Errata to IEEE Guide for Specification of Transmission Static Synchronous Compensator (STATCOM) Systems

Developed by the
Substations Committee
of the
IEEE Power and Energy Society

Correction Sheet
10 May 2021

Figure B.8—Examples of equivalent impedance areas based on a set of system conditions

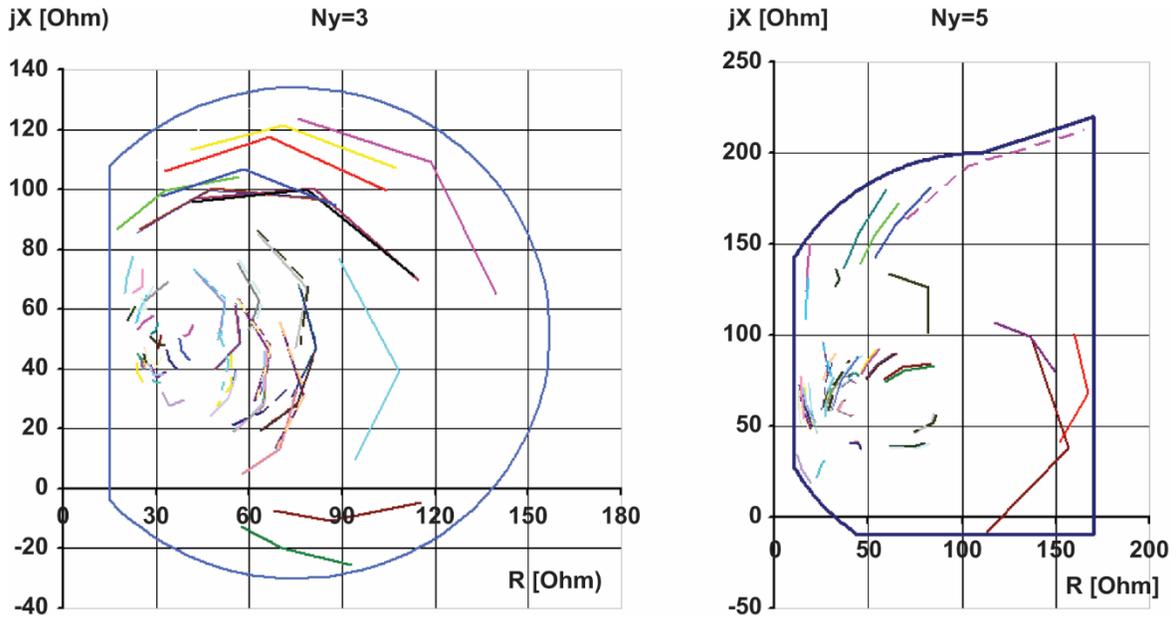
In Annex B, under subclause B.5.4.2 on page 67, please replace the existing figure incorrectly depicted as Figure B.8 with the following:
